**Meridian Airport Authority, Dean Aircraft Services
Hangar Additions & Alterations**

ADDENDUM NO. 4

TO: All Bidders on the Above Referenced Product
FROM: Davis Purdy Architects, PLLC
DATE: March 17, 2020
SUBJECT: **ADDENDUM NO. 4**

E-104

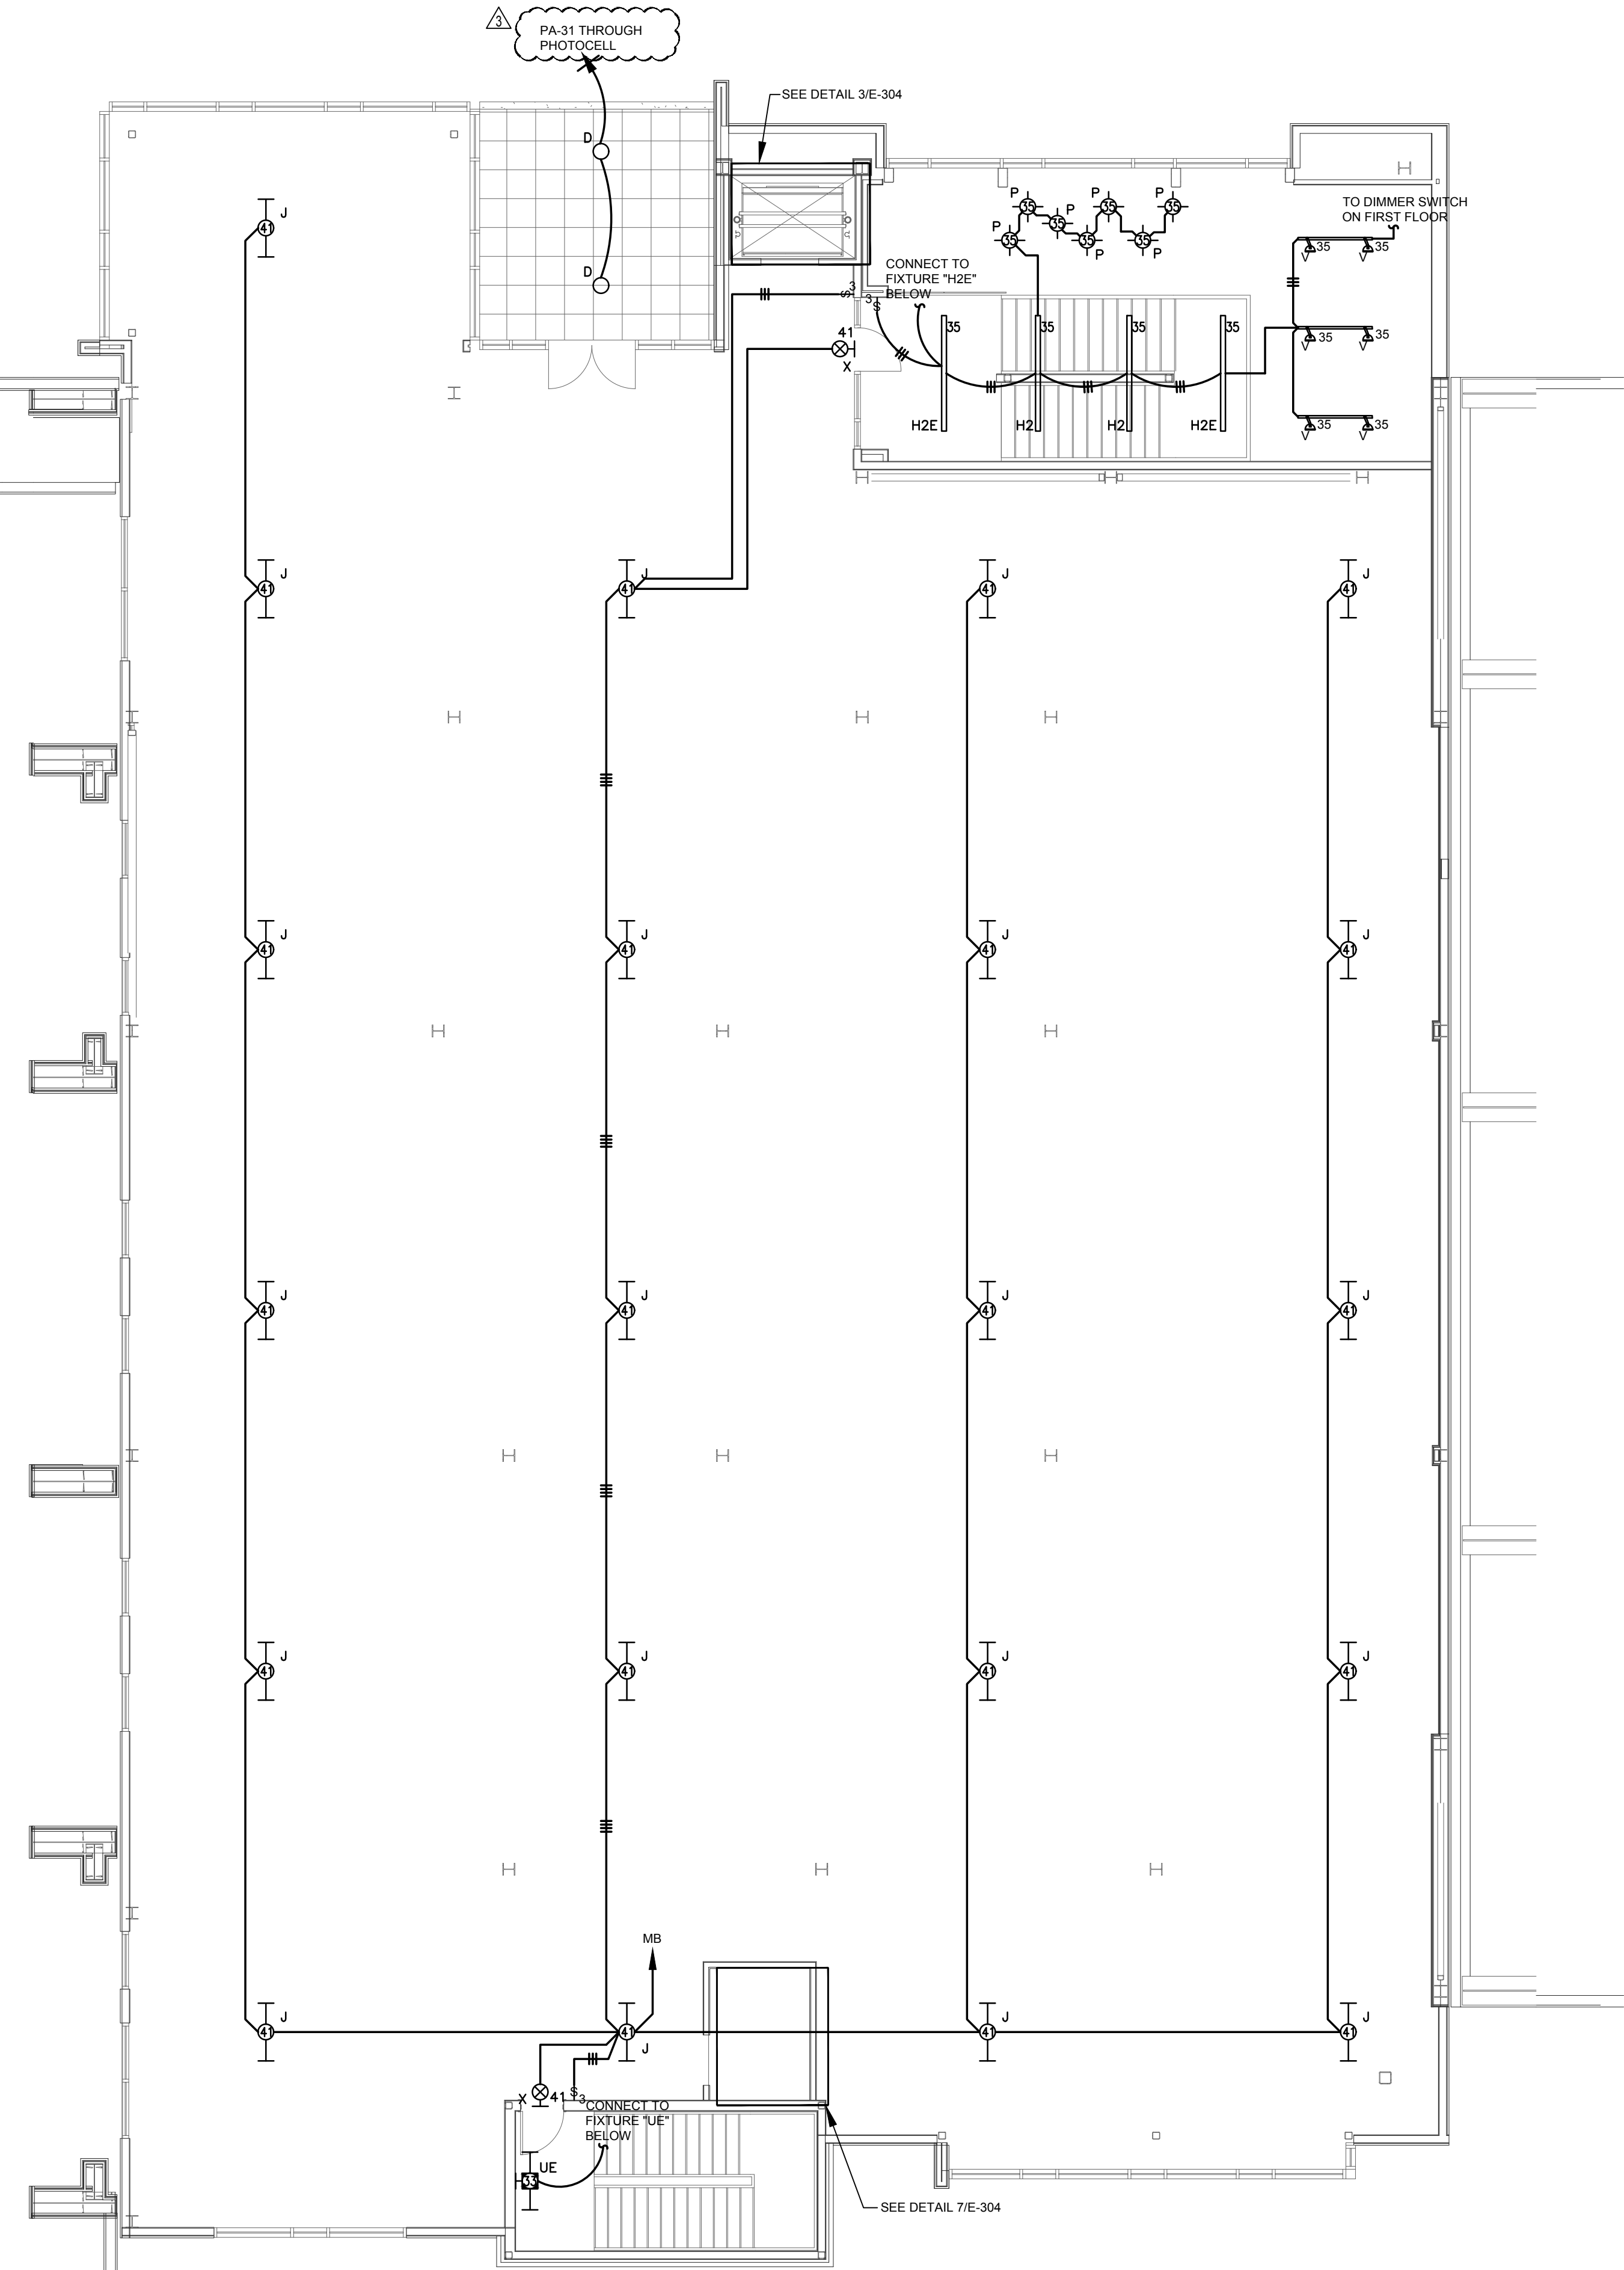
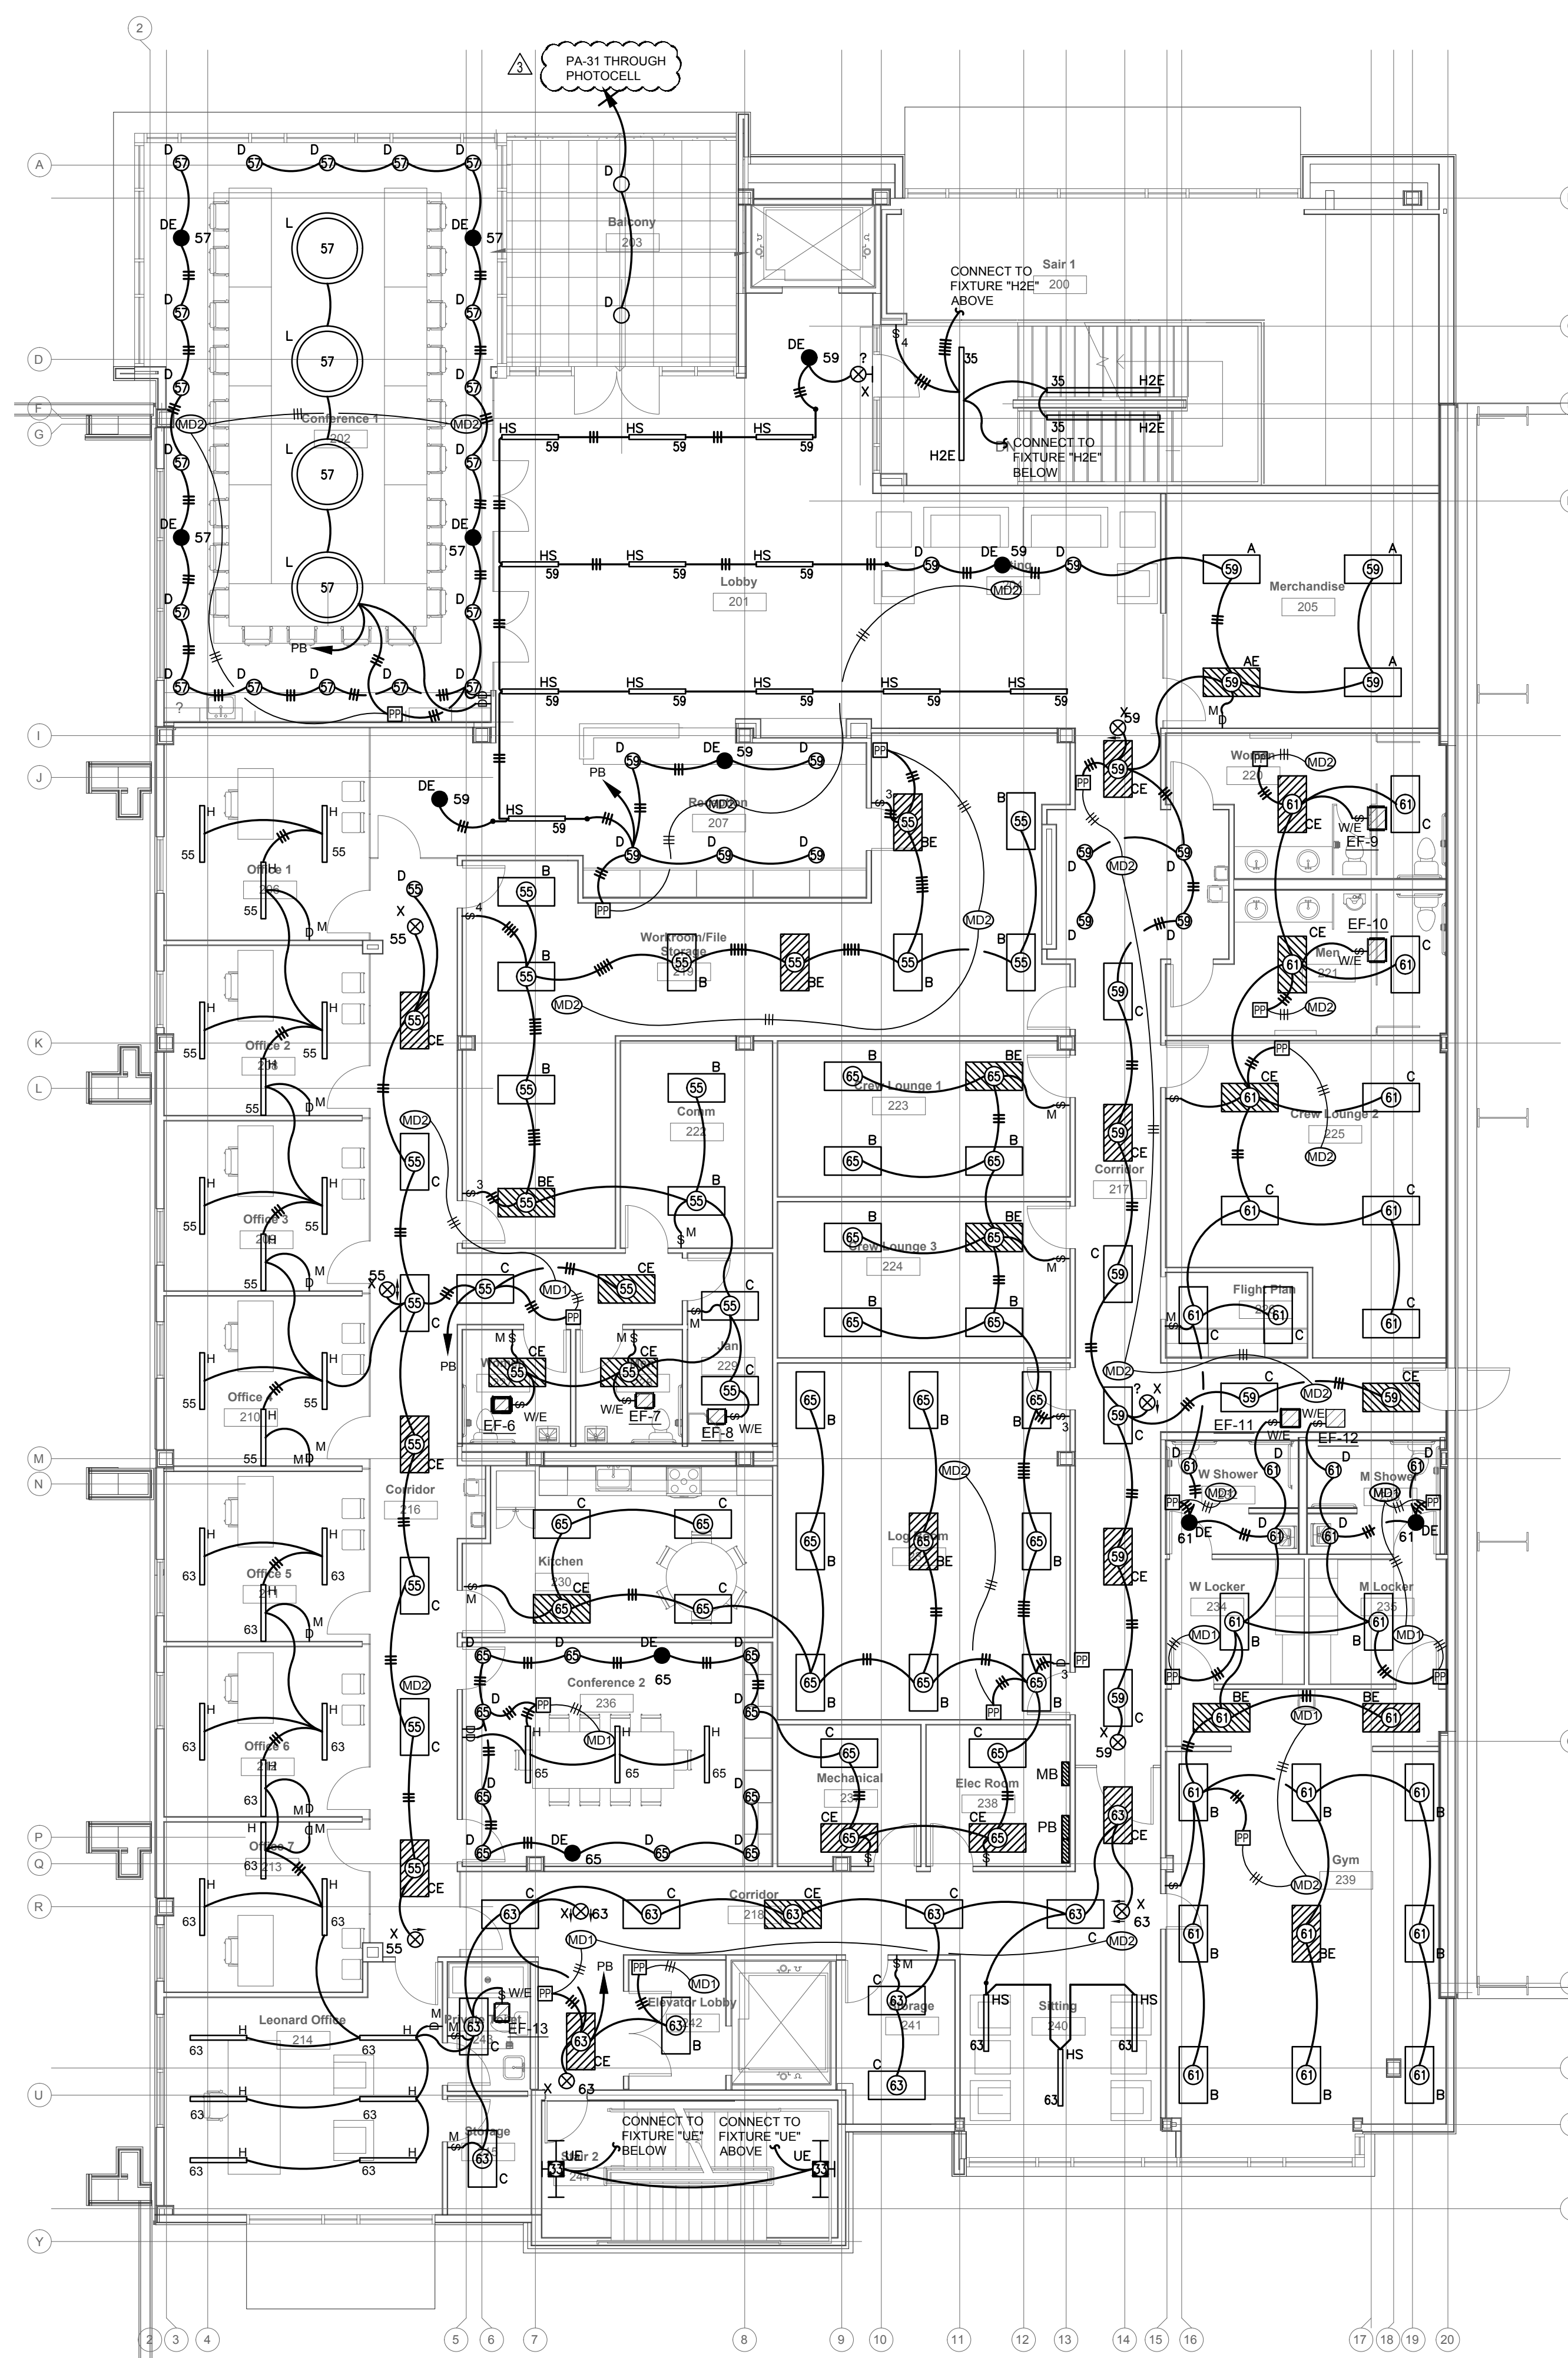
- e. E-103 PARTIAL LIGHTING PLAN 2ND FLOOR PART D**
 - i. Modified exterior fixtures controls.
 - f. E-104 PARTIAL LIGHTING PLAN 2ND & 3RD FLOOR**
 - i. Modified exterior fixtures controls.

E-105

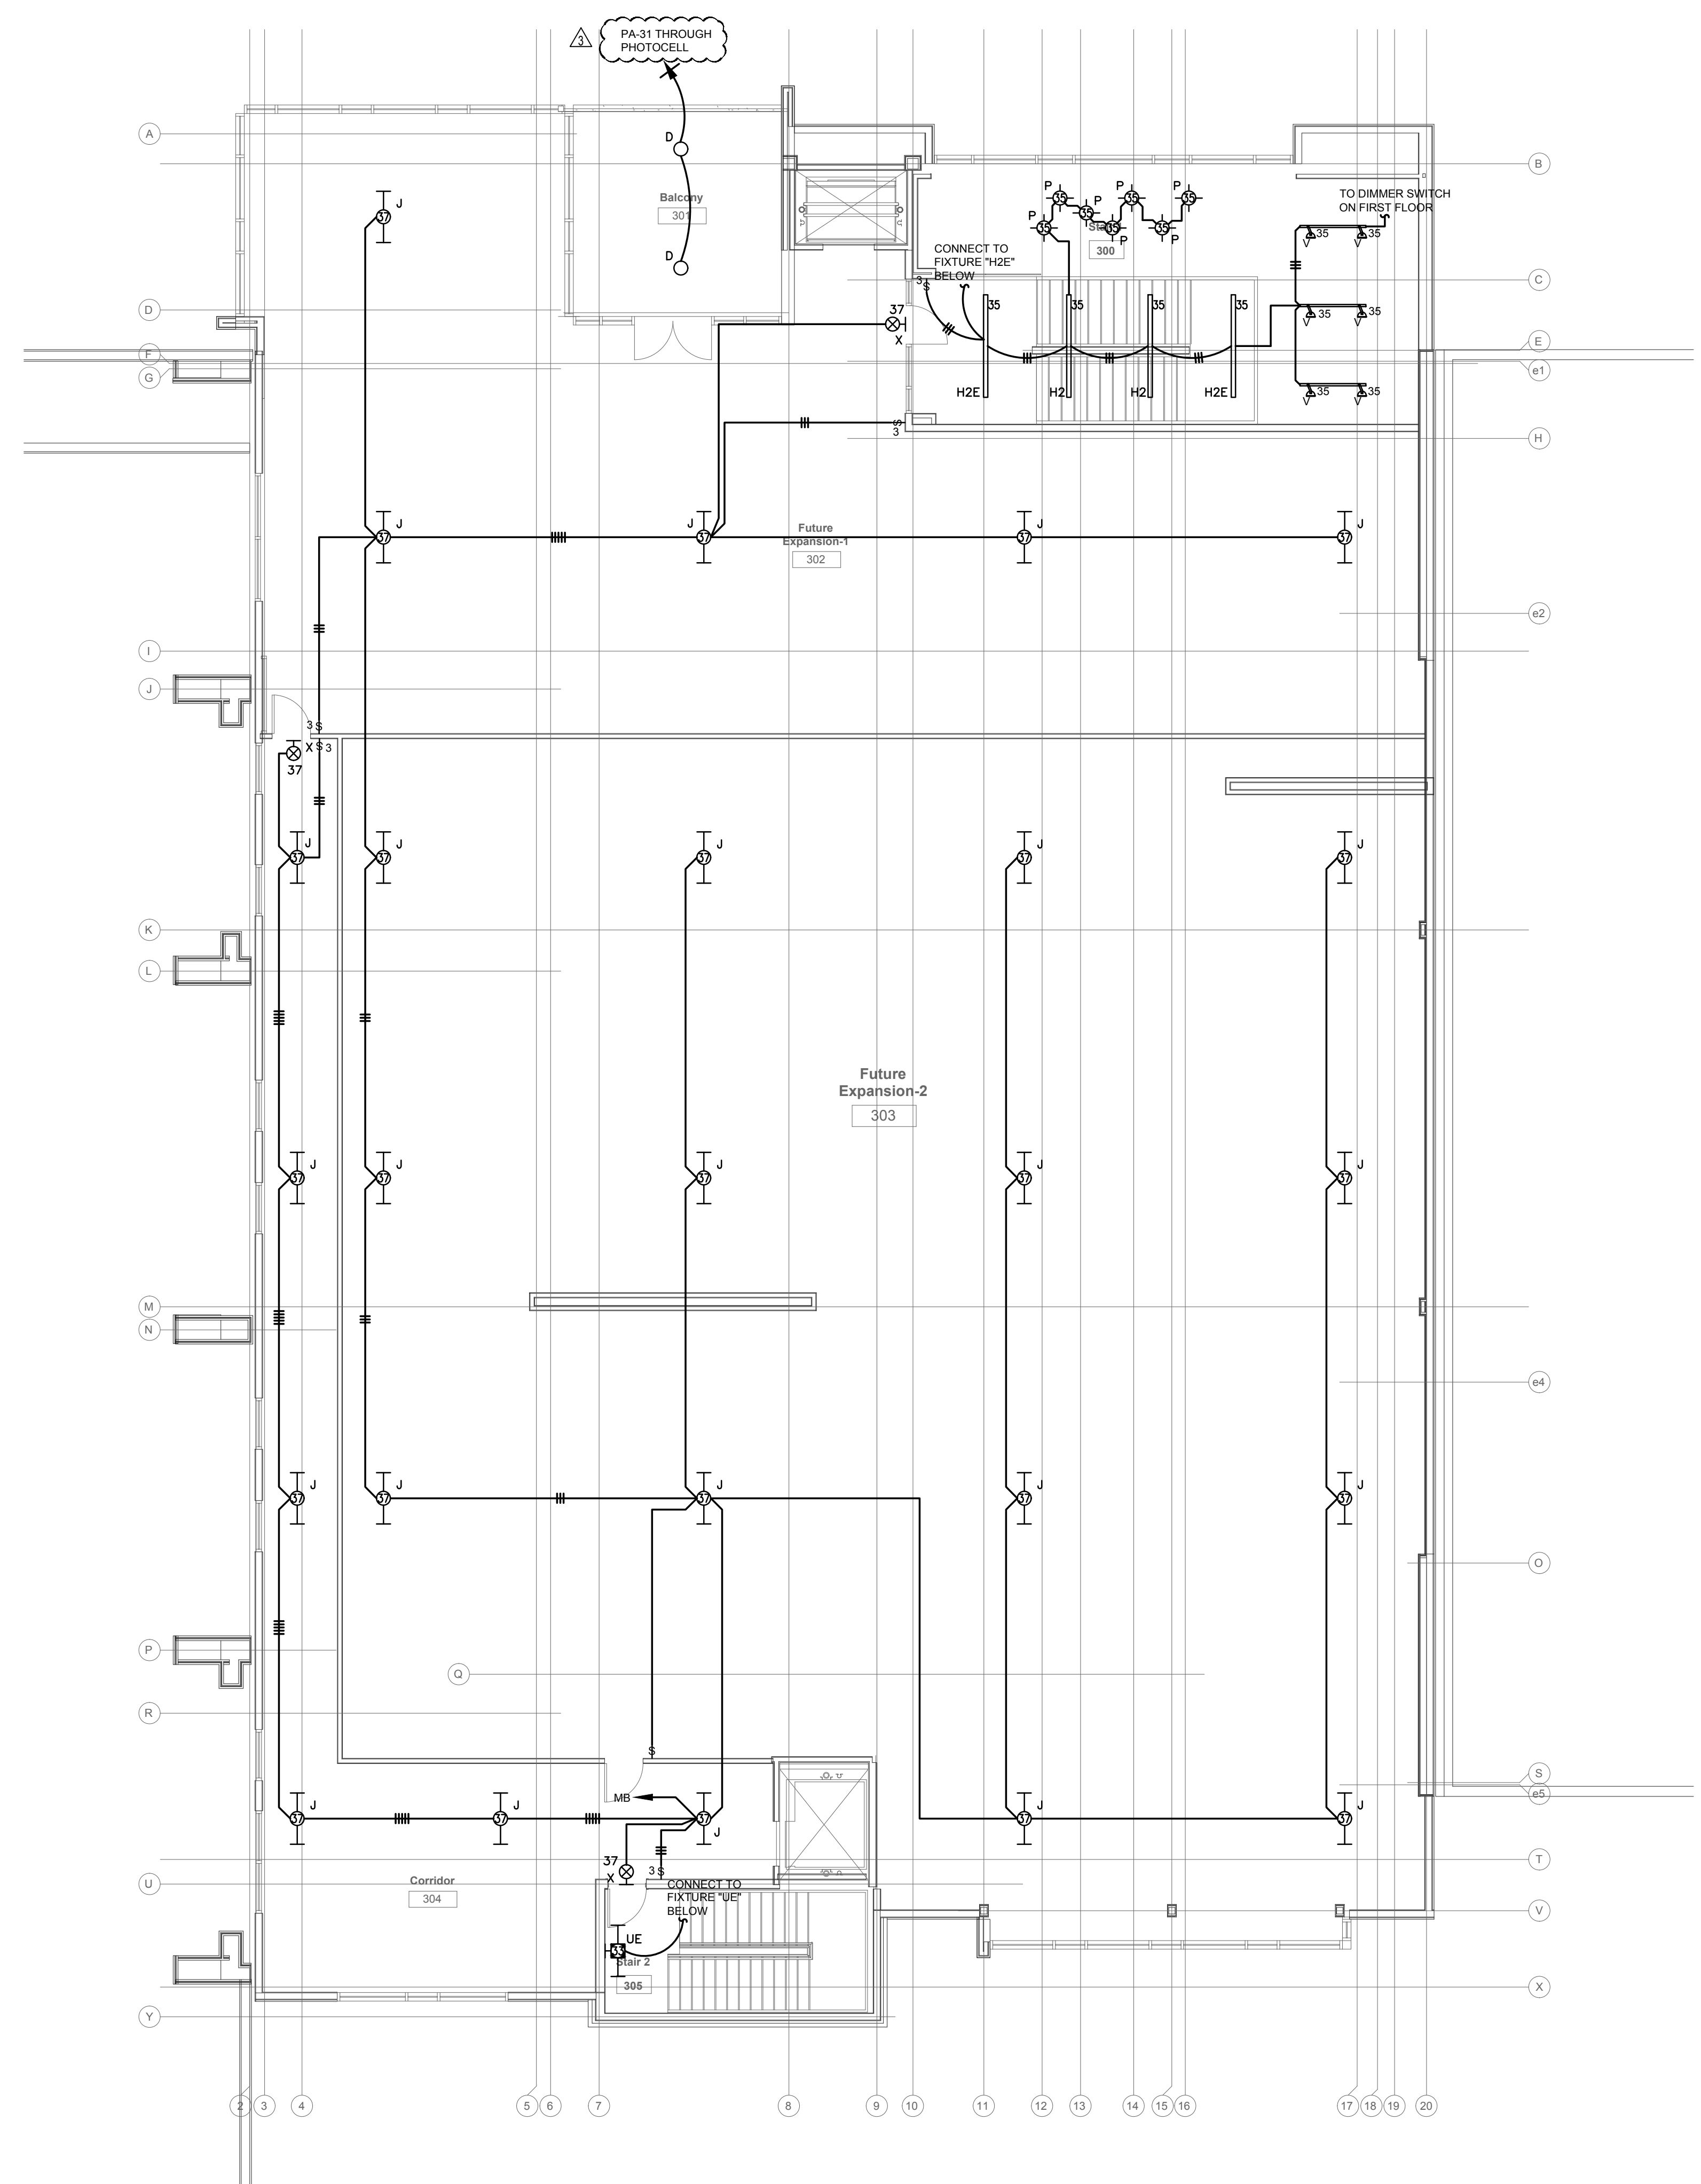
- g. E-105 PARTIAL LIGHTING PLAN 3RD FLOOR**
 - i. Modified exterior fixtures controls.
 - h. E-202 PARTIAL POWER PLAN 1ST FLOOR PART B**
 - i. Modified Receptacle mounting heights.
